Town of Medway
DESIGN REVIEW COMMITTEE
155 Village Street, Medway MA 02053
(508) 533-3291

DRC Meeting Minutes: Monday, August 30, 2021
Zoom (Remote) Meeting

Review of updated Site Plan and Master Signage Plan – Medway Place Shopping Plaza (98, 108 and 114 Main Street)

Re: Medway Plaza, 98, 108, 114 Main Street, Medway, Massachusetts
Application for Major Site Plan Review

C1.00

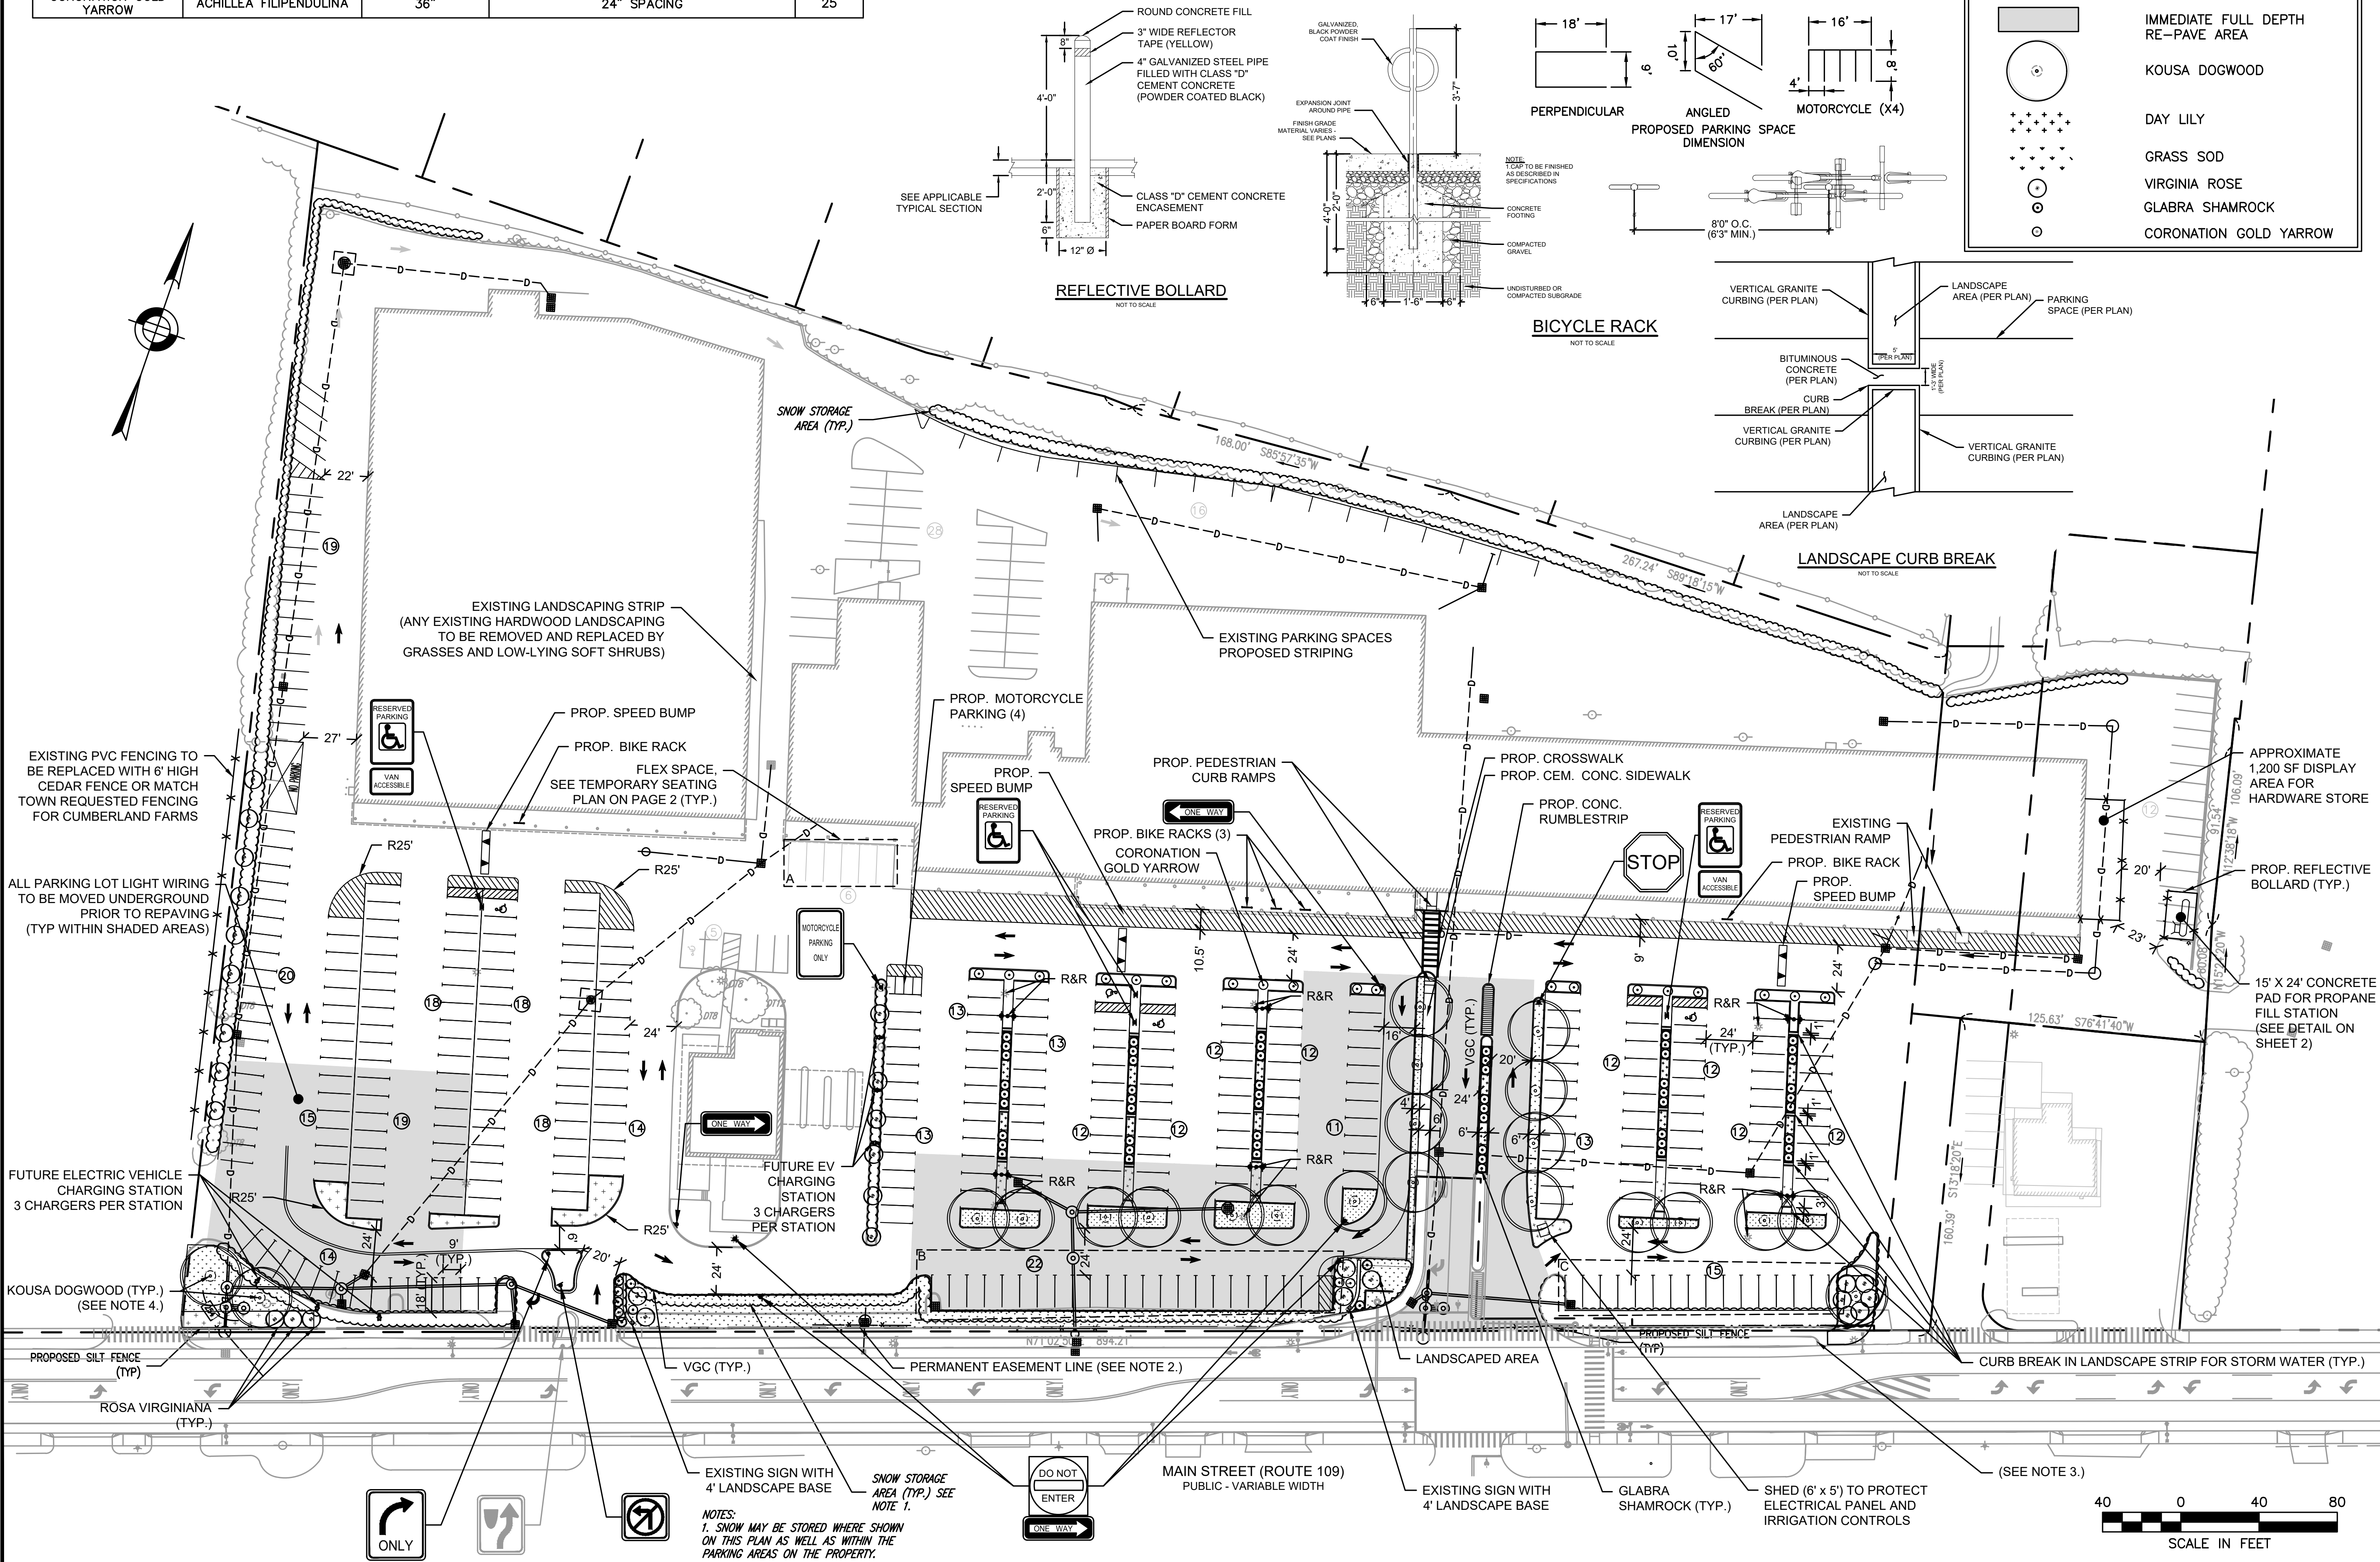
6. **Section 207-13-G(3)(a) requires parking drive aisles to be 24 feet wide. Most of the aisles are one-way for angle parking and those aisles are 18 or 19 feet wide. Section 207-13-G(2)(b) allows for angle parking if the applicant can show proper maneuverability can be achieved. However, pull through angle parking is not allowed. It is not clear if this is achieved. The aisles are now 24' wide except for one-way aisles.**

7. **Section 207-13-I requires electric charging stations. Under the formula, 9 charging stations are required for 400-500 spaces. Electric charging stations providing 9 charging ports are now included in the plan.**

8. **Section 207-19-B(2) requires perimeter landscaping around the entire site. The plan now shows perimeter landscaping along most of the Main Street frontage. The areas are labeled as “Landscaped area”, but details of the landscaping are not provided.**

9. **Section 207-19-C(1)(a) requires that a minimum of 10% of internal parking area shall be provided as landscaped island areas, exclusive of perimeter landscaping. 207-19-C(1)(b) requires landscape islands at the ends of rows with more than 15 parking spaces. ... Section 207-19-C (1)(d) requires at least 1 deciduous shade tree per 6 parking spaces. ... The plan says there are 433 spaces so 72 trees would be required. There are 22. The parking rows now have landscaped islands except for the three rows in front of Ocean State Job Lot. The applicant says that contractual obligations preclude the islands at these locations.**

- Medway Realty will plant 22 kousa dogwoods in the locations identified on the Revised Site Plan.
- Medway Realty will widen both the east and west entrances to Medway Plaza to 20 feet to provide better emergency access.
- Medway Realty will change the landscaping in the approximately 20-foot wide passageway between Ocean State Job Lot and the adjacent building to grass and/or soft, low-lying plants that will not interfere with the use of this passageway by emergency vehicles.
- Medway Realty will improve the west side of the property with a six-foot high cedar fence, which is the same fencing on the Cumberland Farms property cited by the Board.
- Portions of the parking lot will be reserved for flex space and will be cordoned off by large concrete planters for use as outdoor seating and for food trucks, in the event those uses receive all other necessary approvals.

- Medway Realty will landscape the areas surrounding the monument signs with Virginia Rose, Glabra Shamrock, and Coronation Gold Yarrow, all low-lying plants that will not obstruct the signs.

RESPONSE: This appears to be resolved. Notably, in addition to increasing the aisle width, Medway Realty will realign the parking spaces so that they will be perpendicular to the aisles, and will install granite

RESPONSE: Medway Realty has proposed a total of nine charging stations. In response to comments, the charging stations will be split up into two locations, as shown on the Revised Site Plan. Medway Realty would agree to a condition that the charging stations be installed and operable within five years. Prior to resurfacing the relevant portion of the parking lot, Medway Realty will put in place the conduits necessary to connect these charging stations to the grid when installed.

RESPONSE: The Revised Site Plan includes substantial landscaping in light of the existing conditions and shows what plants and flowers will be planted in these areas.

RESPONSE: Medway Realty believes that the proposed landscaping, consisting of 22 kousa dogwoods, raised landscape islands at the end of aisles except for those few aisle ends by Ocean State Job Lot, raised landscape areas between parking rows, and other features is appropriate given the reason for and the scope of changes in the parking lot. Medway Realty has not proposed raised landscape islands at the end of the parking rows near Ocean State Job Lot due to concerns with emergency vehicle access, not contractual obligations. However, the absence of trees in the portion of the parking lot that primarily serves Ocean State Job Lot is due to concerns with contractual obligations.
